Review of Miami-Dade Back Bay Coastal Storm Risk Management Study

Draft Integrated Feasibility Report and Programmatic Environmental Impact Statement
August 4, 2020

Comments by:

Figure 4. Modeled Areas with Save Points within Refined Focus Areas

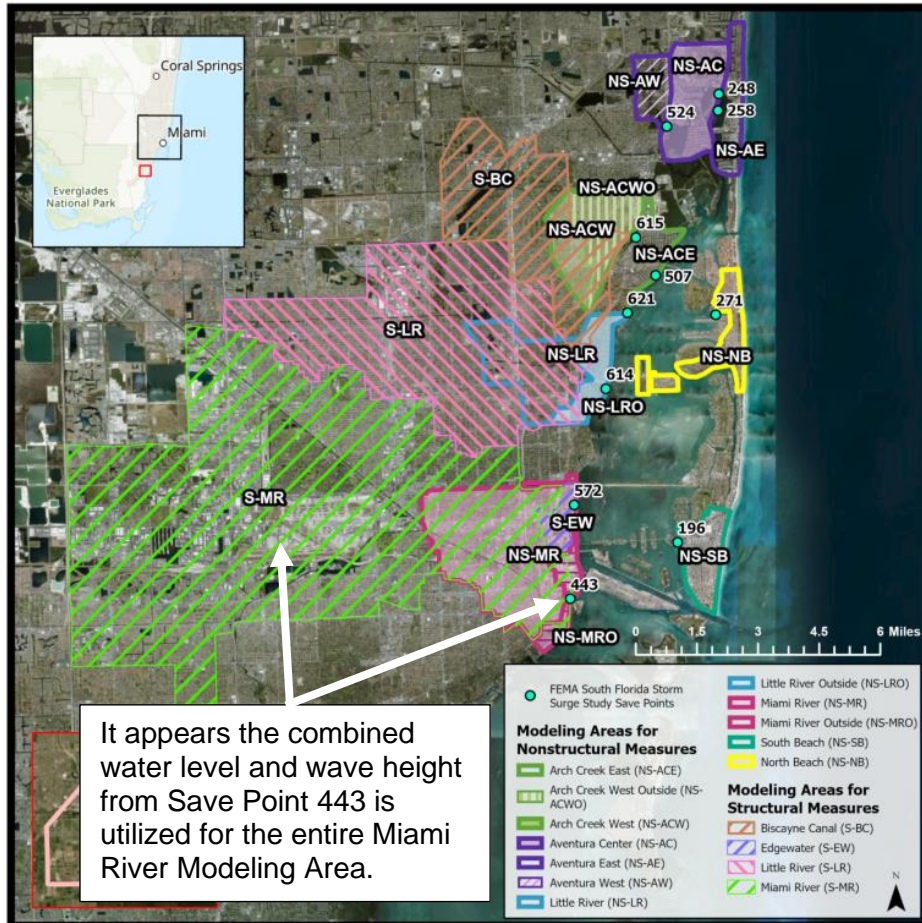
26. Water levels and associated flooding depths appear significantly overestimated in the economic model. The Report states the flooding level in the economic model to be dictated by 12 “save points” spread out for the various areas analyzed. For example, the flooding associated with the analysis of the flood wall at Miami River, Brickell and downtime Miami appears based on one single “save point” at the mouth of the Miami River, refer to the Report’s Figure 4 below. The wave height for a 100-year event at that “save point” is listed at 7.25 feet for a 100-year storm event. Based on the model documentation, the economic model includes 70% of the wave height in the water level to determine flood impacts, associated damage and cost. This would mean 5.1 feet is added to the storm surge level for the entire Miami River model area including far inland. While this may be appropriate at the mouth of Miami River, it appears to *significantly overestimate flooding in all other areas* not directly fronting the Bay, refer to the Report’s Figures 4 and 7 below. As a comparison, the storm surge value is only +7.3 feet NAVD and +10.6 feet NAVD for year 2018 and 2079 (with SLR) respectively. Thus, if existing ground elevation is at +6 feet NAVD, the resulting water depth in 2018 is 1.3 feet, however, it is our understanding a water depth of 6.4 feet would have been used in the economic model. Overestimation of flooding will lead to an associated overestimate in damage cost, which will positively skew the benefit cost ratio of the floodwall solution. Areas with significantly different wave condition variations should be split in smaller areas. In addition, regions of higher ground elevations may restrict the reach of

flooding if lower water elevations were deemed appropriate and result in overall reduction in flood impact footprint. Please update an economic model based on the above.

Figure 7.7. Depth (feet) Inundation layer from HEC-RAS for the Without Project and Without Precipitation at 1% 2079 SWL including SLR and Storm Surge. All focus areas - Scenario 1.

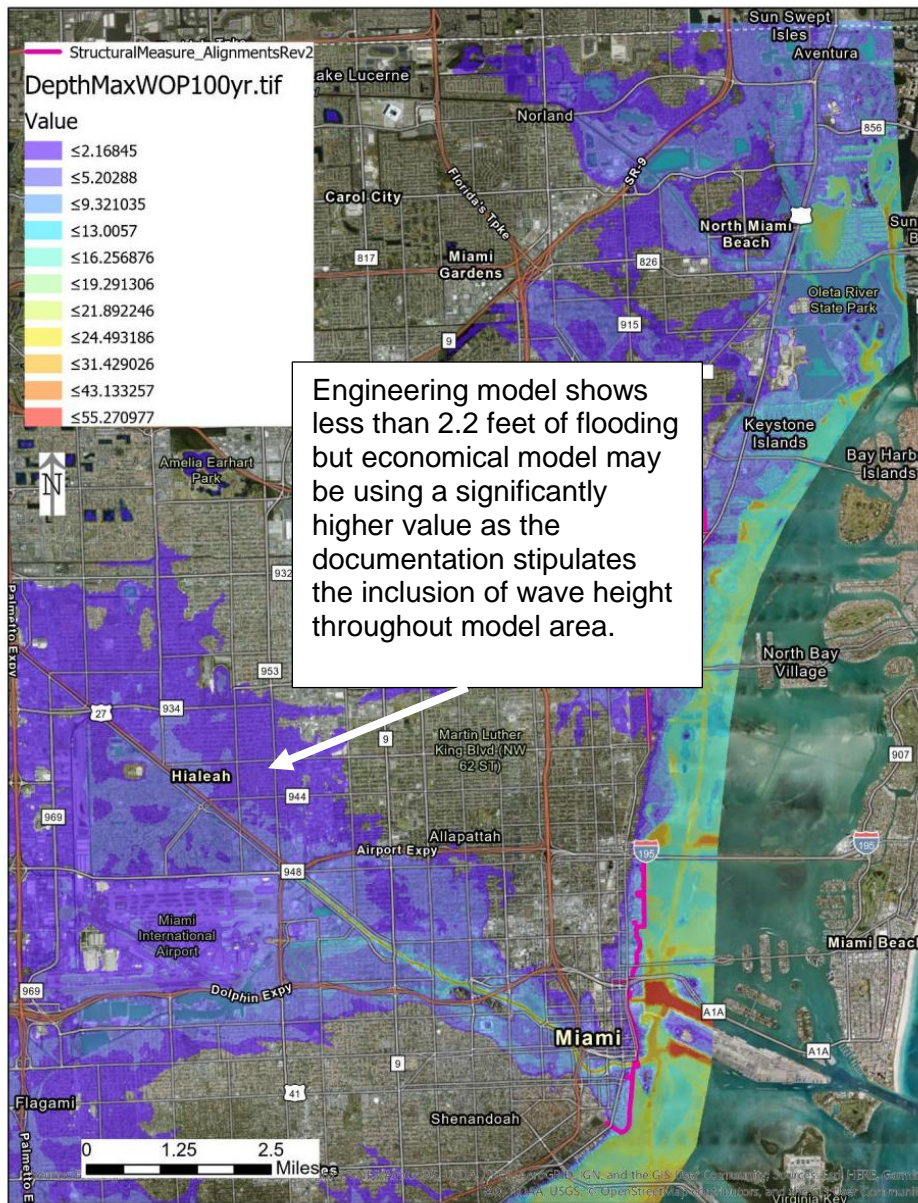
16. Flooding maps are difficult to interpret due to legend choice (e.g. 2.16845, 5.20288, 9.321035), i.e. difficult to distinguish if flooding is 3 inches or 2 feet. Recommend updating legend(s) with smaller intervals and even values.
